**REGULAR MEETING OF THE  
 ARAPAHOE COUNTY PLANNING COMMISSION  
 TUESDAY, SEPTEMBER 20, 2016 AT 6:30 P.M.**

<b>SUBJECT: Z16-003 – SKY RANCH, PRELIMINARY DEVELOPMENT PLAN AMENDMENT.</b>	
<b>P16-011 – SKY RANCH, PRELIMINARY PLAT.</b>	
<b>SHERMAN FEHER, PLANNER.</b>	<b>September 12, 2016</b>

Date: September 7, 2016  
To: Sherman Feher, Planning Division  
From: Sue Liu, Engineering Division  
RE: Z16-003 P13-011 Sky Ranch PDP PP

**SHEET**  
**5 OF 24**  
**OVERALL**  
**PRELIMINARY**  
**DEVELOPMENT PLAN**  
**EXHIBIT**  
 REPLACES SKY RANCH PDP, AMENDMENT NO. 1  
 CASE NUMBER A04-010, SHEET 3 OF 9  
**PDP AMENDMENT NO. 2**

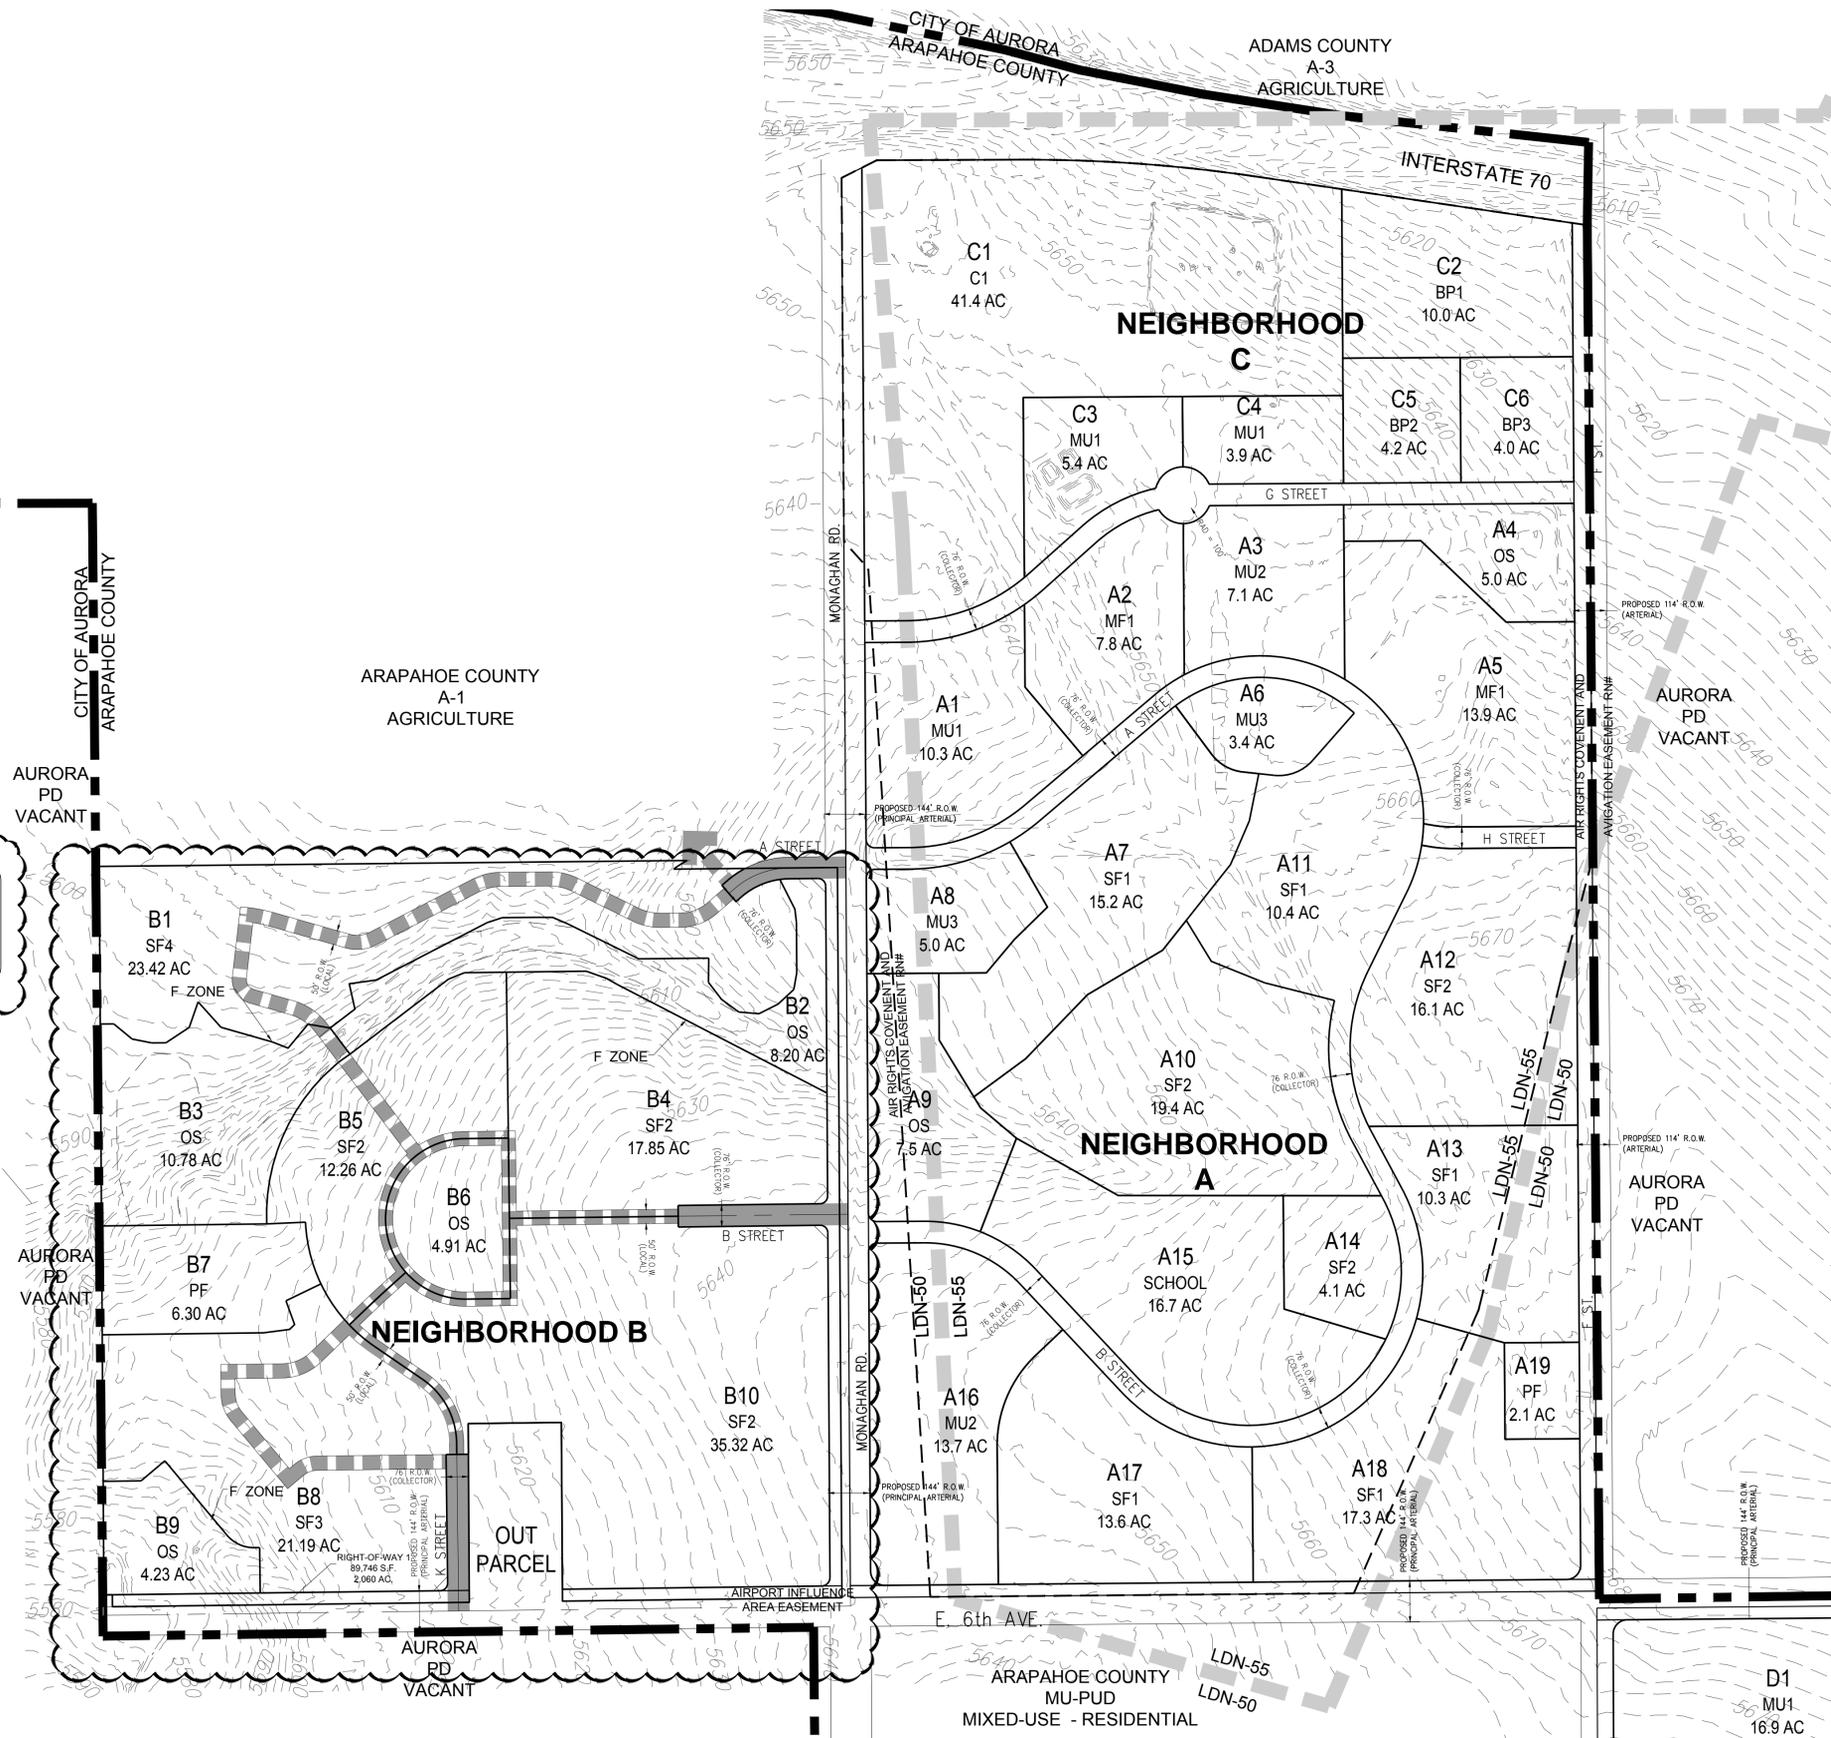
8. Comment: Please call out the source of the designation for one hundred-year floodplain of First Creek and Trib. T-9.  
**Response: First Creek's Floodplain is defined by FEMA Panel No.: 08005C0206L. The Trib T-9 source is defined by CVL's analysis, "Sky Ranch Floodplain Study", dated August 2016. A note to this effect has been added to Sheet 5 of 24 of the PDP.**

4. Comment: As previously commented please include a note similar to the following on Sheet 3: Detention and Water Quality facilities will be designed with the Final Development Plan however these facilities shall be located in the following areas \_\_\_\_\_.

***Response: In relation to the above comment, a note has been added to Sheet 5 of 24 as requested.***

NOTE:  
1. FIRST CREEK'S FLOODPLAIN IS DEFINED BY FEMA PANEL NO. 08005C0206 L. THE TRIB T-9 SOURCE IS DEFINED BY CVL'S ANALYSIS. "SKY RANCH FLOODPLAIN STUDY", DATED AUGUST 2016

**SHEET**  
**6 OF 24**  
**PRELIMINARY**  
**DEVELOPMENT PLAN**  
**EXHIBIT (NORTH**  
**PORTION)**  
REPLACES SKY RANCH PDP, AMENDMENT NO. 1  
CASE NUMBER A04-010, SHEET 4 OF 9  
**PDP AMENDMENT NO. 2**

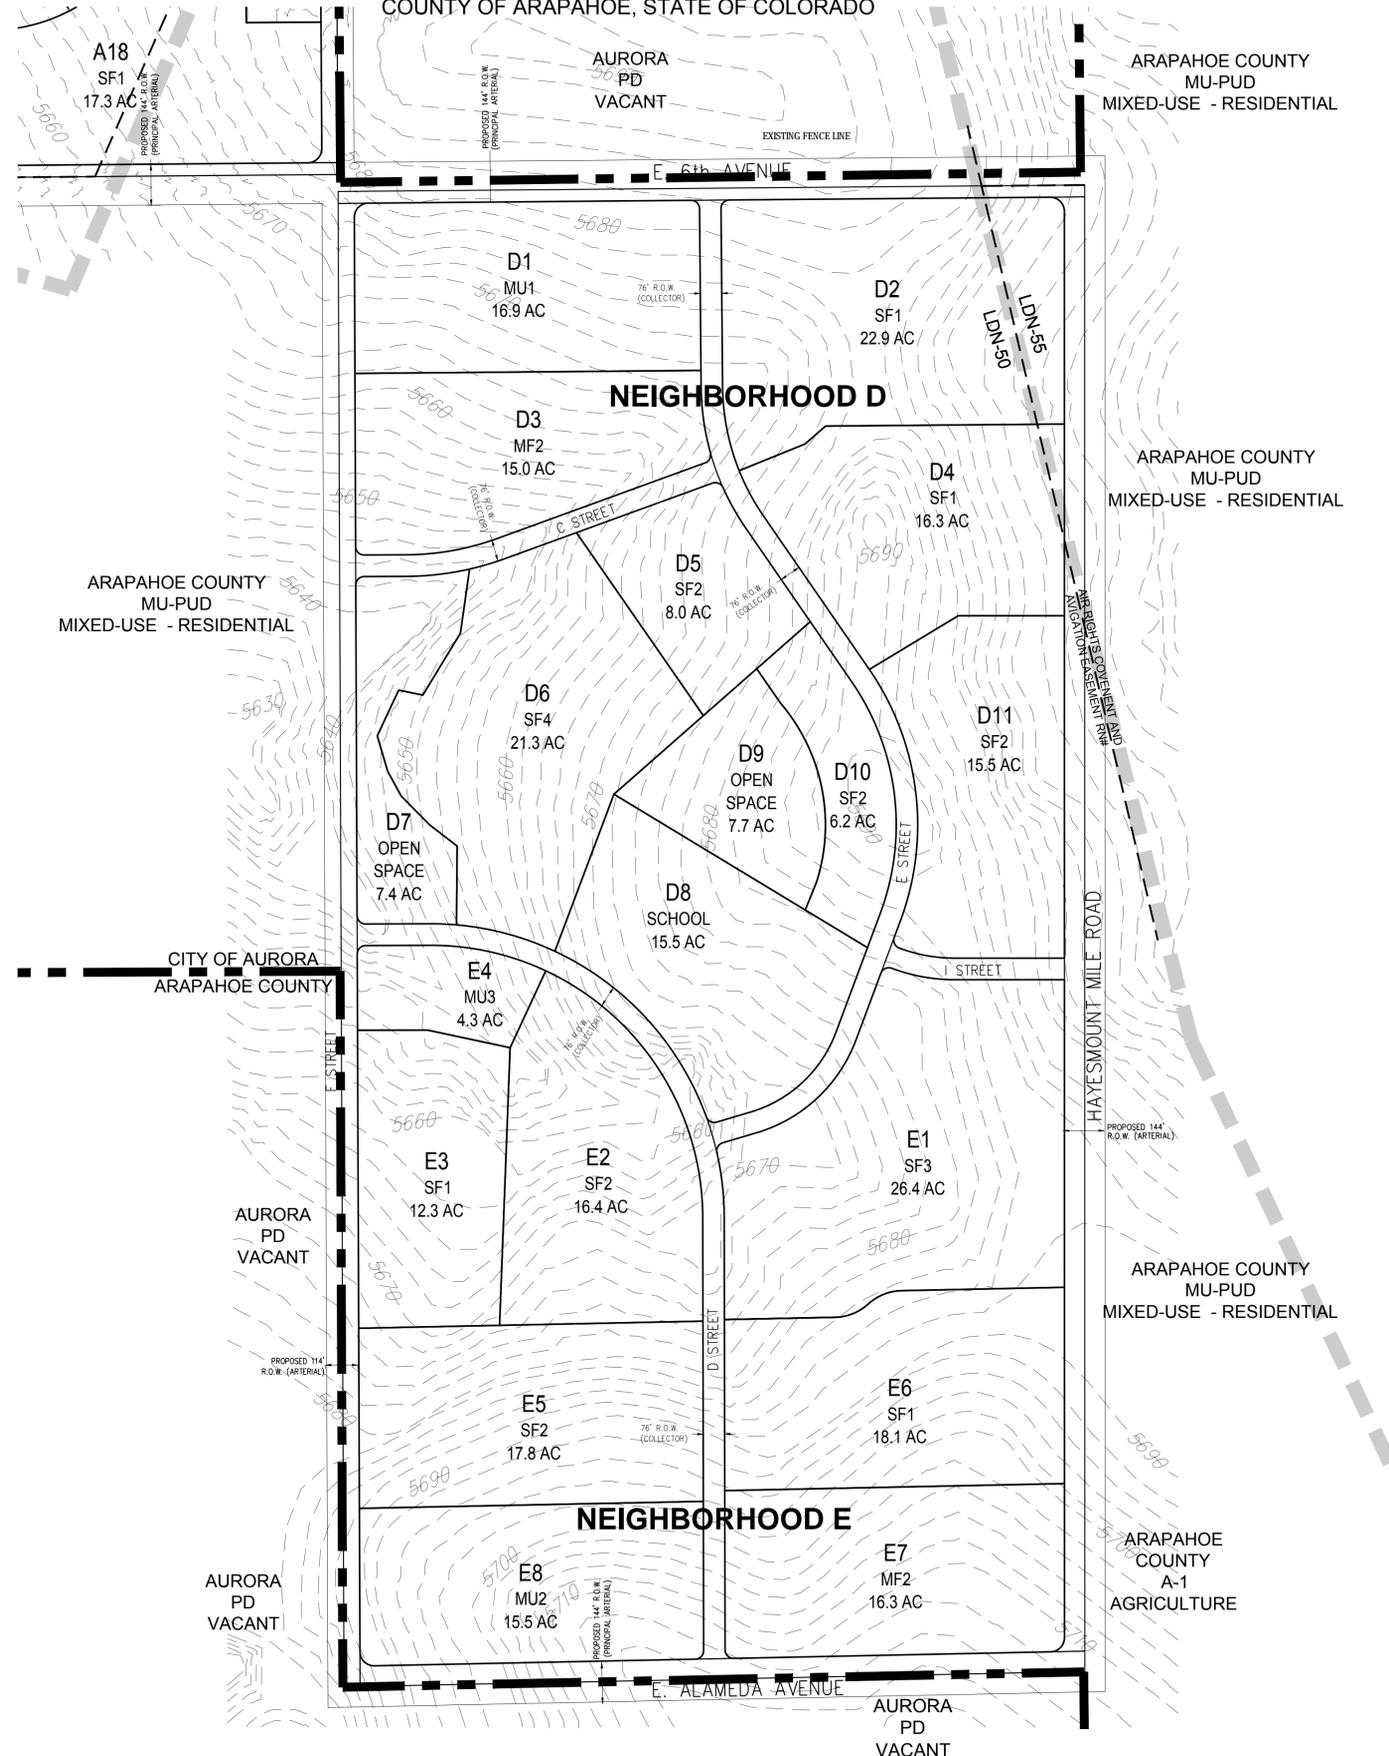
2. Comment: On Sheets 6 and 16 the F Zone is labeled. Is this the area that is being zoned floodplain? or the floodplain delineation itself. Please show and label the floodplain delineation as previously commented.
